Initial Product/Process Change Notification

Document #: IPCN23267X

Title of Change:	SPM32 direct bonding copper (DBC) substrate pattern change.
Proposed First Ship date:	15 Oct 2020 or earlier if approved by customer
Contact Information:	Contact your local ON Semiconductor Sales Office or Daisy.Zhi@onsemi.com
PCN Samples Contact:	Contact your local ON Semiconductor Sales Office or PCN.samples@onsemi.com Sample requests are to be submitted no later than 30 days from the date of first notification, Initial PCN or Final PCN, for this change. Samples delivery timing will be subject to request date, sample quantity and special customer packing/label requirements.
Type of Notification:	This is an Initial Product/Process Change Notification (IPCN) sent to customers. An IPCN is an advance notification about an upcoming change and contains general information regarding the change details and devices affected. It also contains the preliminary reliability qualification plan. The completed qualification and characterization data will be included in the Final Product/Process Change Notification (FPCN). This IPCN notification will be followed by a Final Product/Process Change Notification (FPC

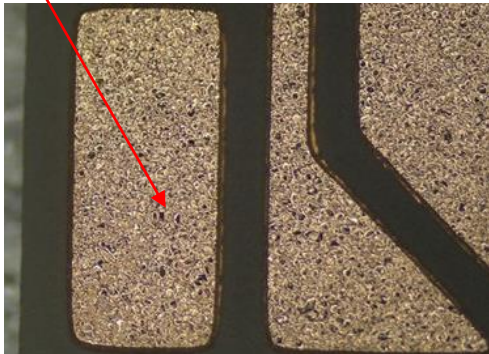
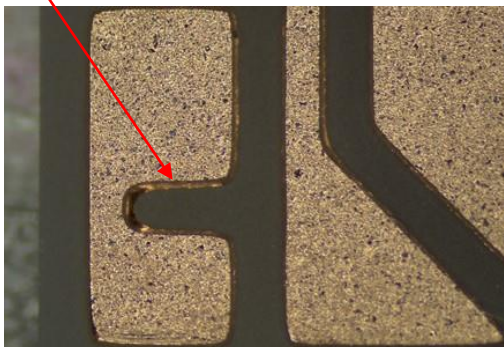
DBC left bottom corner shape is rectangle in current and will change to etched in the future.

Before Change Description	After Change Description
DBC pattern change	<p>DBC left bottom corner shape is rectangle</p>  	<p>DBC left bottom corner shape is etched</p>
